# Fitzgerald Marine Reserve (FMR)

A Review of Infrastructure Projects and Natural Resource Protection Issues

MCC presentation February 13, 2013 by Lisa Ketcham

## FMR Beach Access Trail – 2010 plan on hold

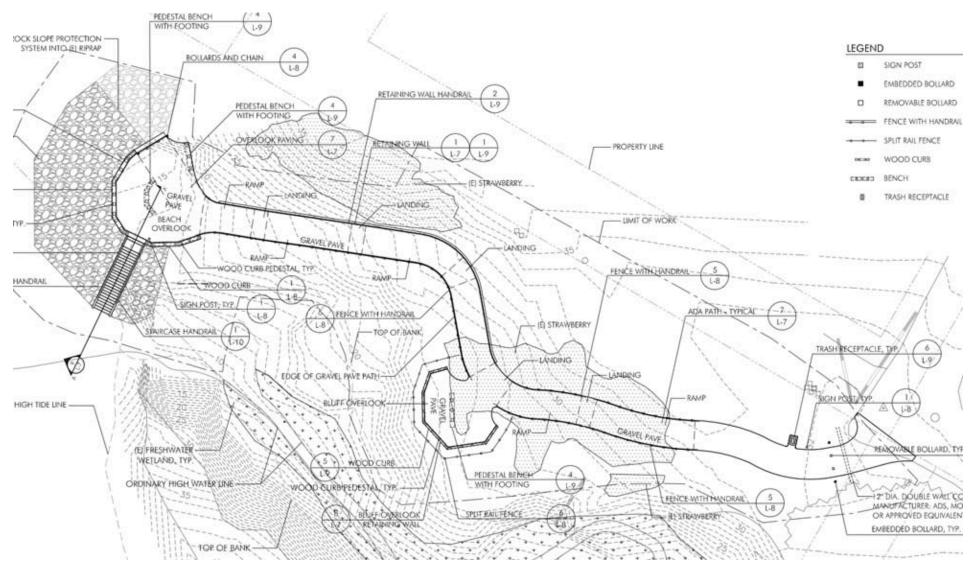
New coastal armoring structure to support lower overlook will cover about 3 times as much beach as the overlook itself. New switchback 10-ft-wide trail route, road cuts, and 6-ft tall retaining wall will completely alter the natural landscape and views.

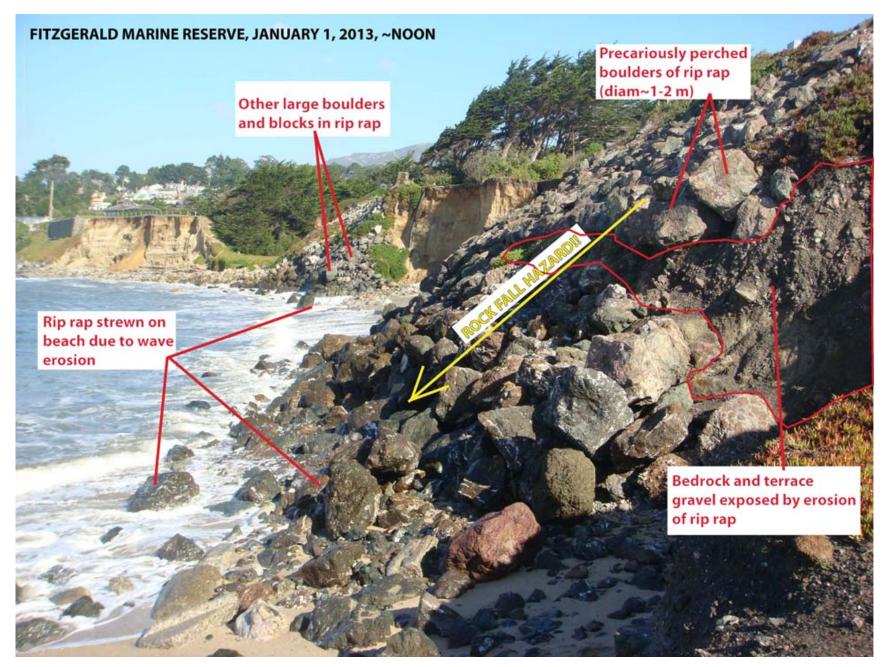
FMR beach access trail is currently ADA-accessible to this upper overlook. The lower overlook is above beach level on an old deteriorating structure of rock and concrete rubble piled onto the beach.

Lower overlook structure as viewed from the beach – project calls for complete rebuilding with massive 3-layer rock armoring extending out over the beach with a new stairway to the beach.
